Access Compliance Report

Public Rights-of-Way

| Intersection ID: 30121 | Main Street: CLOONEY_LN | Cross Street: VERNON_WOOD_LN | Location: NW |
| ADA ID: A343C05BAF16 | Ramp Type: PerpDiag | Initial Pass/Fail: Fail | Overall Compliance: No |

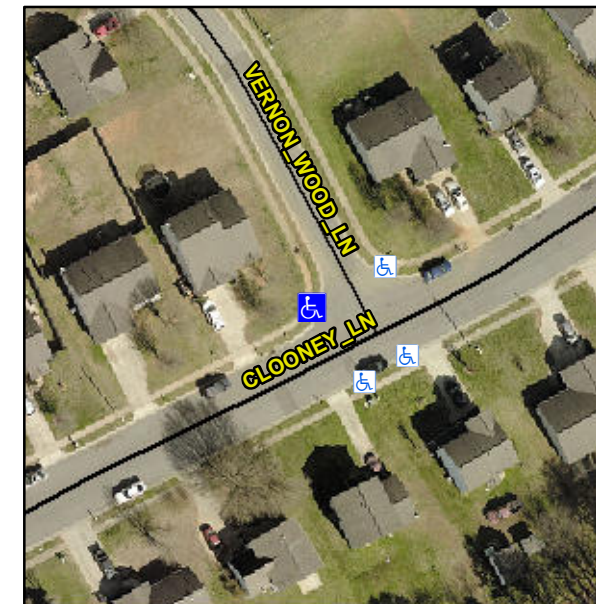
Not Found, R304.5.1, R304.2.2, R304.5.3

| Compliance | Description | Data | Compliance | Description | Data |
|------------|-----------------------|------|------------|-----------------------------|------|
| N/A | Ramp Length (in) | 48.0 | No | Ramp Slope (%) | 10.8 |
| No | Ramp Width (in) | 44.0 | No | Ramp XSlope (%) | 4.9 |

Remove & Replace Curb Ramp With Two New Directional Ramps or Equivalent.
